<b>Project</b>	IEEE 802.16 Broadband Wireless Access Working Group < <a href="http://ieee802.org/16">http://ieee802.org/16</a> >	
<b>Title</b>	QoS Control Scheme for data forwarding in 802.16j	
<b>Date Submitted</b>	2007-04-25	
<b>Source(s)</b>	<p>Hang Zhang, Peiyong Zhu, Mo-Han Fong, Wen Tong, David Steer, Gamini Senarath, Derek Yu, Mark Naden, G.Q. Wang</p> <p>Nortel 3500 Carling Avenue Ottawa, Ontario K2H 8E9</p> <p>Ranga Reddy US Army - CERDEC, USA</p> <p>D. J. Shyy MITRE, USA</p> <p>Arnaud Tonnerre THALES COMMUNICATIONS, FRANCE</p> <p>Djamal-Eddine Meddour FRANCE TELECOM, FRANCE</p> <p>Jeffrey Z. Tao, Koon Hoo Teo, Jinyun Zhang</p> <p>Mitsubishi Electric Research Lab 201 Broadway Cambridge, MA 02139 USA</p> <p>Toshiyuki Kuze Mitsubishi Electric Corp 5-1-1 Ofuna Kamakura, Kanagawa 2478501, Japan</p> <p>Aik Chindapol Jimmy Chui Hui Zeng Siemens Corporate Research</p>	<p><a href="mailto:Ranga.Reddy@us.army.mil">Ranga.Reddy@us.army.mil</a> Voice: +1 732-532-0085</p> <p><a href="mailto:djshyy@mitre.org">djshyy@mitre.org</a> Voice: +1 703 983 6515</p> <p><a href="mailto:arnaud.tonnerre@fr.thalesgroup.com">arnaud.tonnerre@fr.thalesgroup.com</a> Voice: +33 1 46 13 2850</p> <p><a href=

Figure XXX. R-MAC header format with QoS info

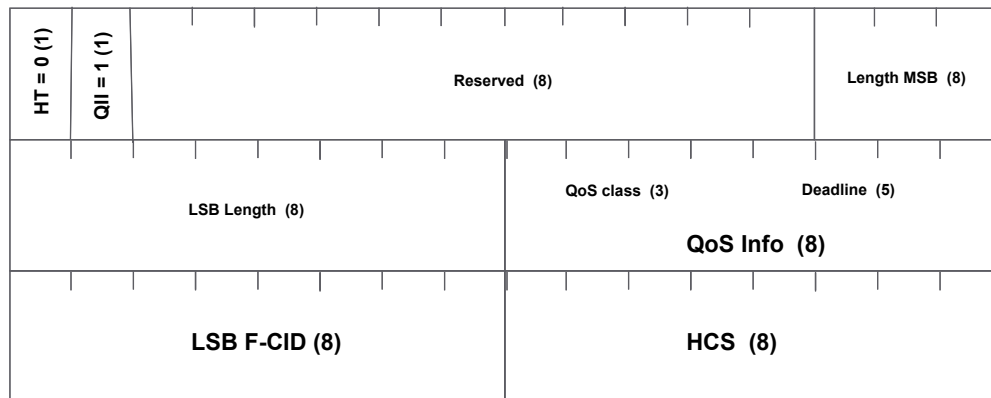
*[Insert the following subclause after the end of Section 6.3.2.1]*

### 6.3.2.1.1.1 Format of R-MAC header with QoS information

The format of R-MAC header with QoS info is shown in the following Figure XXX.
